SUNDRY NOTICES AND REPORTS ON WELLS

8. Well Name and No.
Poker Lake Unit #332H

9. API Well No.
30-015-39845

BOPCO, L.P. is requesting approval to amend point 4 Pressure Control Equipment in the original APD as follows on attached document.

13-5/8" X 3-M BOPE (2 Rams and Rotating Head) & Closed Loop System Equipment Schematic Diagram 2

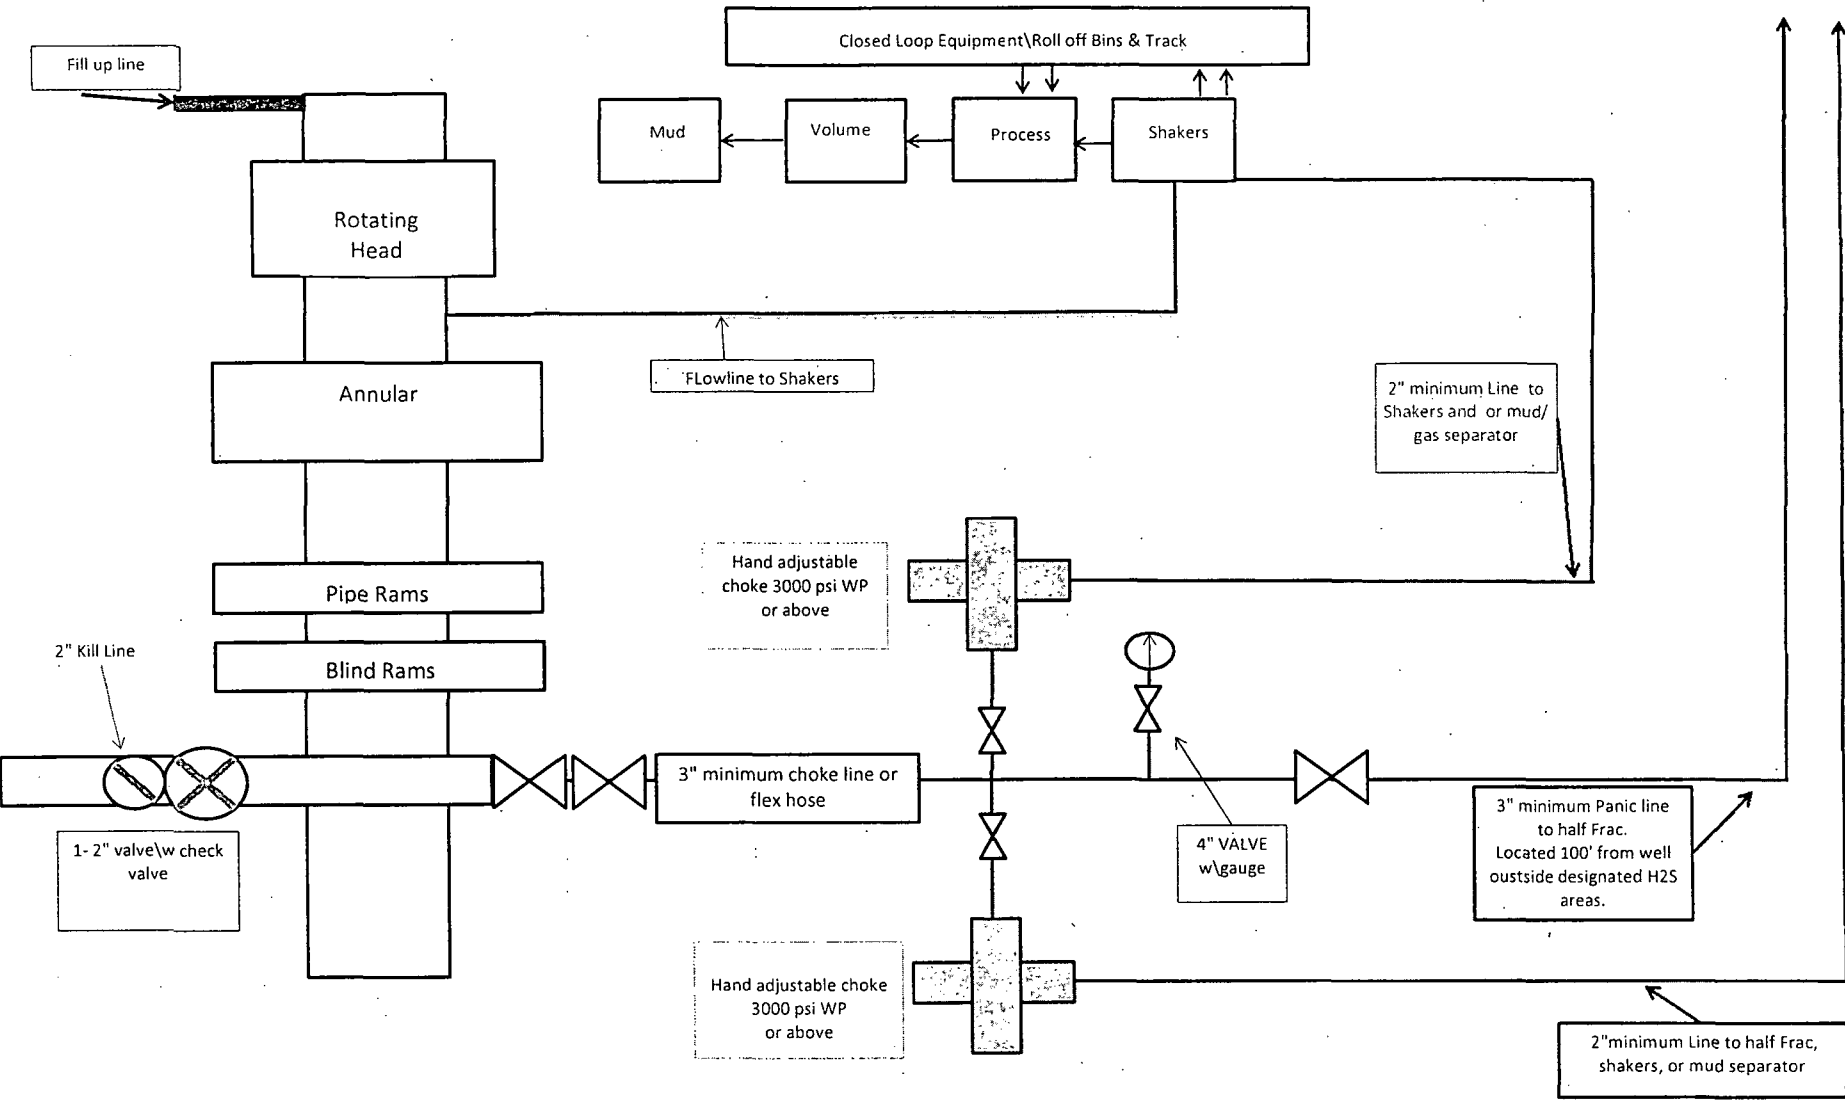
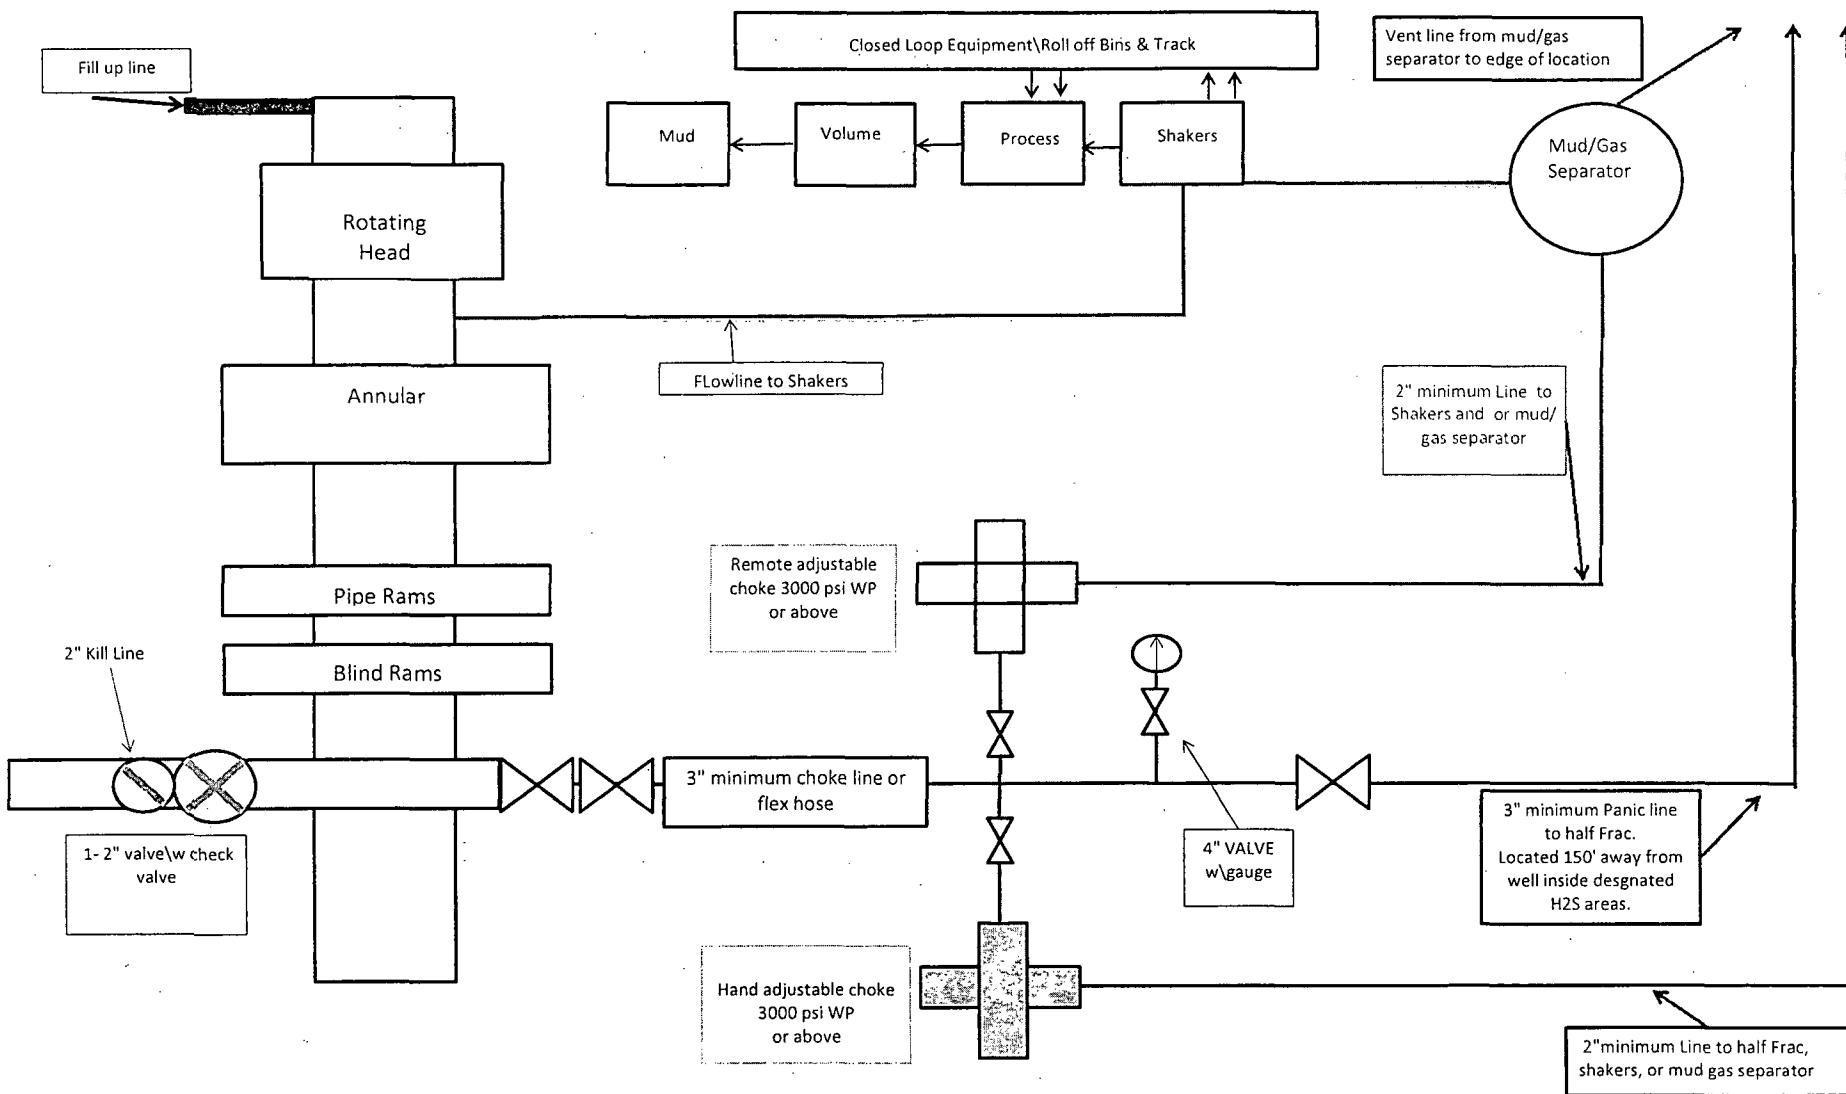
POINT 4: PRESSURE CONTROL EQUIPMENT (SEE ATTACHED DIAGRAM 2)

After running the 13-3/8" surface casing, a 13-5/8" BOP/BOPE system with a minimum rating of 3M will be installed, used, maintained and tested as per Onshore Order 2. In addition to the high pressure test, a low pressure (250-300 psig) test will be performed.

After running the 9-5/8" intermediate casing, a 13-5/8" or 11" BOP/BOPE system with a minimum rating of 3M will be installed on the 9-5/8" intermediate casing spool (8-3/4" open hole), used, maintained and tested as per Onshore Order 2. In addition to the high pressure test, a low pressure (250-300 psig) test will be performed.

After running the 7" intermediate casing, a 13-5/8" or 11" BOP/BOPE system with a minimum rating of 3M will be installed on the 9-5/8" intermediate casing spool (8-3/4" open hole), used, maintained and tested as per Onshore Order 2. In addition to the high pressure test, a low pressure (250-300 psig) test will be performed.

Variance approved to use flex line from BOP to choke manifold. Check condition of flexible line from BOP to choke manifold, replace if exterior is damaged or if line fails test. Line to be as straight as possible with no hard bends and is to be anchored according to Manufacturer's requirements. The flexible hose can be exchanged with a hose of equal size and equal or greater pressure rating. **Anchor requirements, specification sheet and hydrostatic pressure test certification matching the hose in service, to be onsite for review.** If the BLM inspector questions the straightness of the hose, a BLM engineer will be contacted and will review in the field or via picture supplied by inspector to determine if changes are required (operator shall expect delays if this occurs).
